Intel® High Definition Audio Specification

Document Change Notification

Change Identification: **DCN No: HDA043-A**
Change Revision: 1.0
Document Revision: Intel® High Definition Audio 1.0a

Title: **Energy efficient audio buffering and dynamic FIFO limit change**

Figure 14: HD Audio DMA and buffering

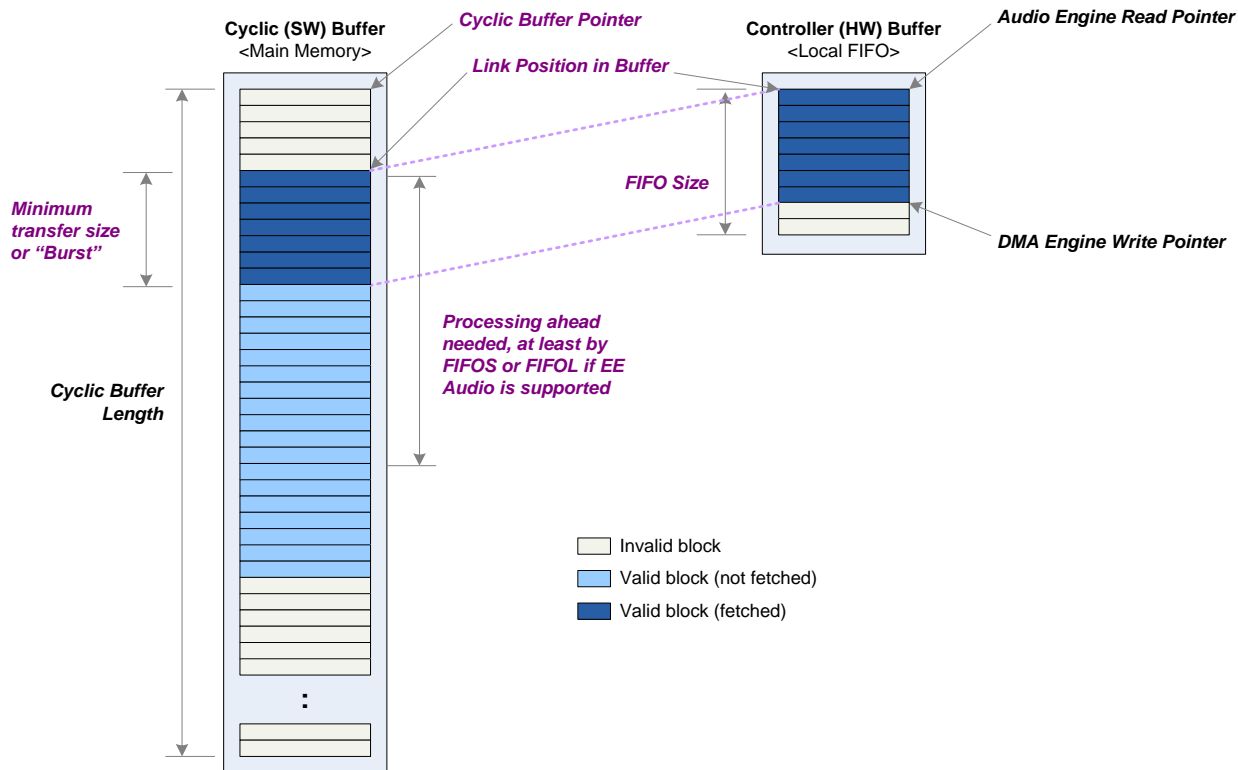
4.6 Energy Efficient HD Audio (EEAudio) Mechanism

The Energy Efficient HD Audio (EEAudio) mechanism enables the SW to control the HD Audio Controller DMA engine effective buffer size extension for power saving versus latency consideration. When configured to use larger extended buffering, it allows the DMA engine to reduce associated system memory accesses, thus allows the CPU to go in to deeper power saving states and reduces the platform power associated with audio streams. When configured to use smaller extended buffering (or disabled), it suits the application where low latency audio processing is required.

The GCAP2 register EEAC bit indicates the HW capabilities of supporting EEAudio. When EEAC bit is set, the FIFOL register is available for SW to specify the limit (in unit of time) that HD Audio Controller DMA engine can access in the Cyclic Buffer, ahead of the Link Position in Buffer; in other words, that defines the maximum limit that DMA engine effective buffer size (in number of bytes) can be extended to. SW shall guarantee processing ahead of this boundary in the Cyclic Buffer. Note that the translation of FIFOL value to effective buffer size needs to take into consideration of number of channels, sample size, multiplier, divider, and base rate.

When EEAudio is supported as indicated by EEAC bit being set, the FIFOS register will expose the minimum buffer size required by HW for efficient operation. SW can allow the extension of the DMA engine effective buffer size beyond the minimum buffer size advertised in FIFOS register for better power management, by writing to FIFOL register followed by setting FIFOSC bit. Depending on the eligible HW buffer size available, DMA engine can then extend its effective buffer size to a value not exceeding the FIFOL specified. Note that some HD Audio Controller DMA engine implementations are capable of changing FIFOS register value based on FMT register programmed, hence, SW shall always read the FIFOS register to find out the FIFO size advertised before writing to FIFOL register.
